Our Ref: PL2222

11 February 2022

**RE: RESPONSE TO OUTSTANDING MATTERS**

**Development Permit for Reconfiguring a Lot (2 Lots into 41 Residential Lots plus New Road,  
Environmental Reserve, Drainage Reserves and Balance Lots (Future Stages))  
381 Rochedale Road and 216 Gardner Road, Rochedale (Lots 1 & 2 on RP115631)  
Council Reference: A004685227**

# Plan of Reconfiguration

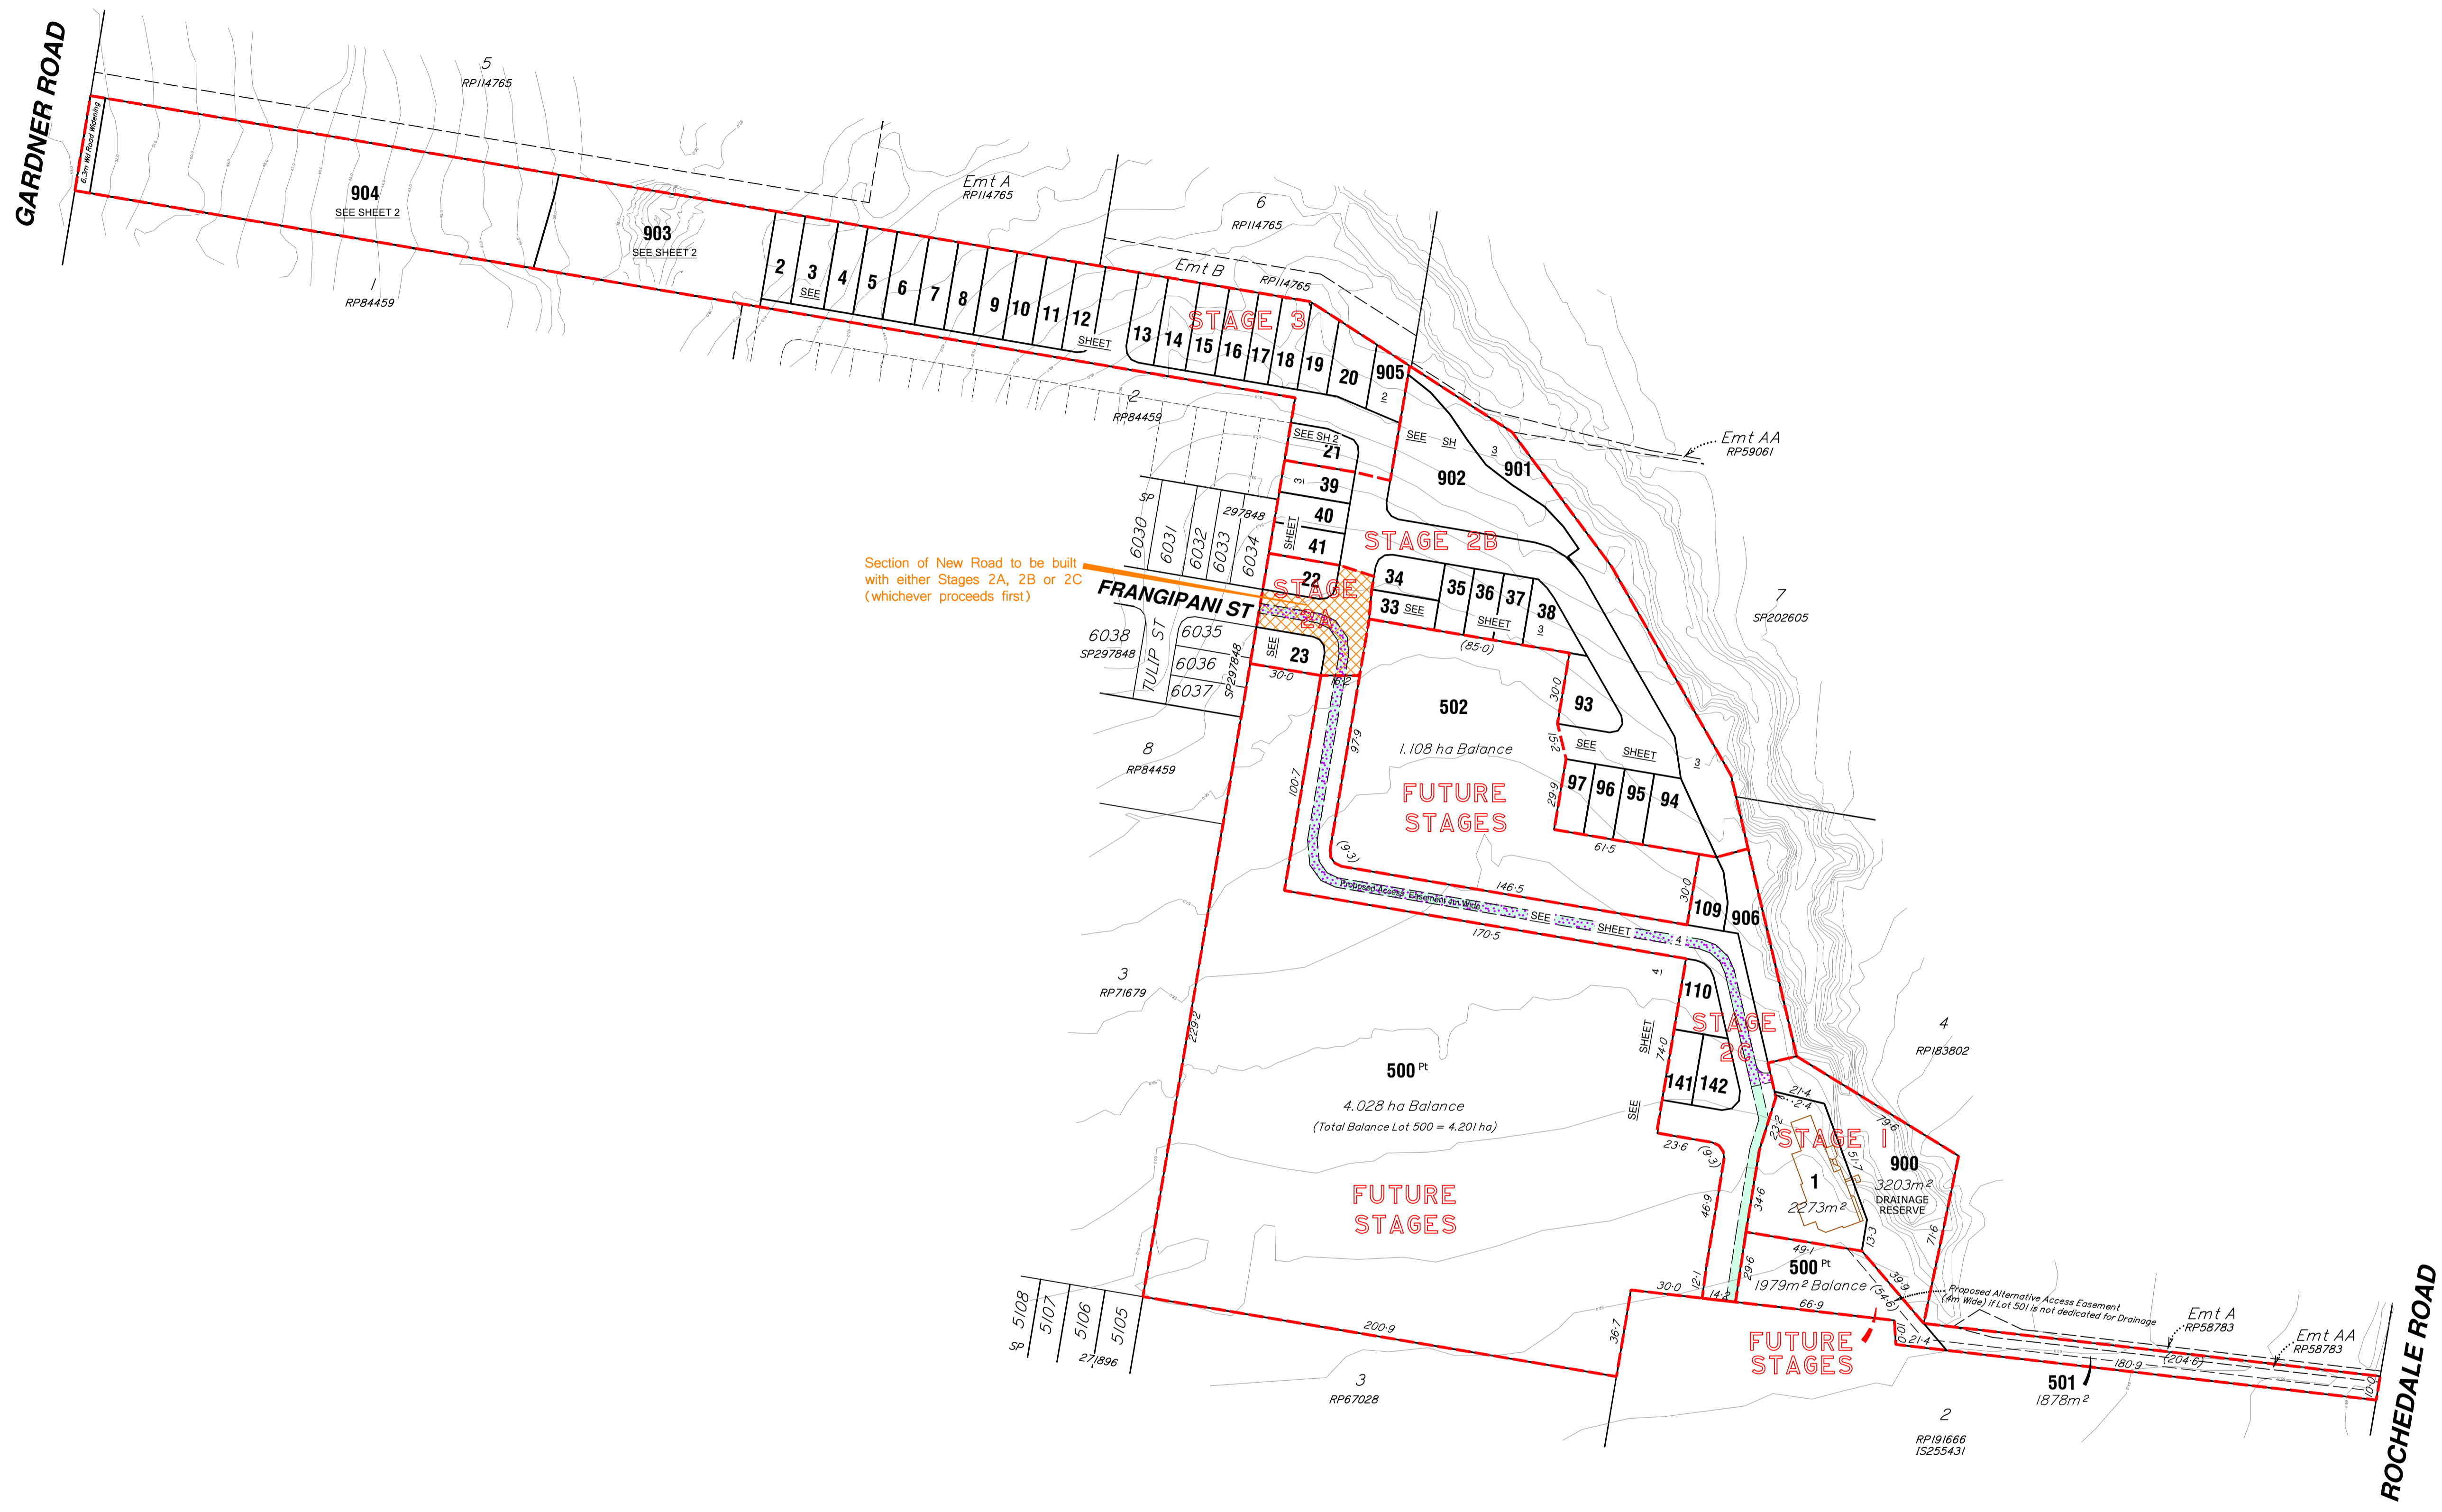
- **Relocation of northern road connection:** the proposed new road connection to the north has been relocated from the edge of the waterway corridor to the location of previous Lot 12, further to the east, in consultation with Council. This provides access to the north-eastern lot, given the north-western lot above the handle is now constrained by State government koala mapping.

This road connection has been widened from 12.5m to 14m given it does not have the benefit of being adjacent to proposed open space. The additional width has been achieved by taking a small portion from Lot 905 and adjacent Lot 20, and the eastern boundary of Lot 20 has been straightened to regularise the shape of this lot, which together are consequential and minor lot configuration changes.

- **Lot 501 and 900 reconfigurations:** minor changes have been made to the size and shape of proposed Lots 501 and 900, adjacent to the existing house lot (Lot 1), to facilitate the future dedication of the access handle (Lot 501) if required and the drainage reserve (Lot 900).
- **Access easement:** as requested by Council, two alternative access easements are shown for Lot 1, connecting to Frangipani Street via the proposed internal road layout if the easement to Rochedale Road is unable to be provided due to the possible dedication of Lot 501.
